RE: S/D 00-12 -- Final Plat of BENCOR FIRST ADDITION

RE: S/D 00-12 -- Final Plat of BENCOR FIRST ADDITION

CASE NUMBER: S/D 00-12 -- BENCOR ADDITION

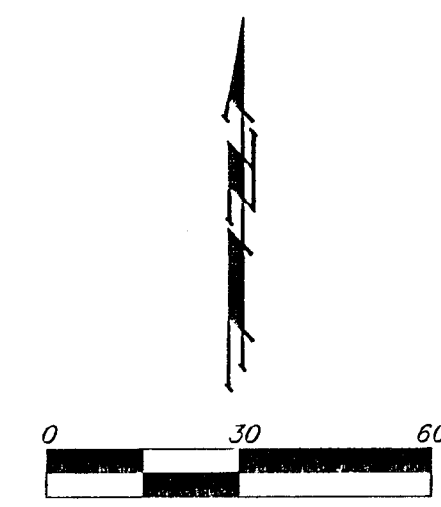
- C. City Engineering needs to comment on the status of the applicant's drainage plan. The drainage plan is approved.
- D. The alley adjoining Lot 2 shall be denoted on the final plat tracing.

- E. The plat proposes one access opening along each perimeter street. The Applicant shall guarantee the closure of any driveway openings being located in areas of complete access control or that exceed the number of allowed openings.

- G. Traffic Engineering should comment on the need for additional right-of-way. In lieu of the standard 75-ft half street right-of-way, the Applicant has dedicated an additional 10 foot of right-of-way in conjunction with a "corner clip". The Applicant shall dedicate a 15-ft contingent right-of-way.

- J. The platlor's text shall include language that a drainage plan has been developed for the plat and that all drainage easements, rights-of-way, or reserves shall remain at established grades or as modified with the approval of the applicable City or County Engineer, and unobstructed to allow for the conveyance of stormwater.

The final plat has included this requested dedication of right-of-way.
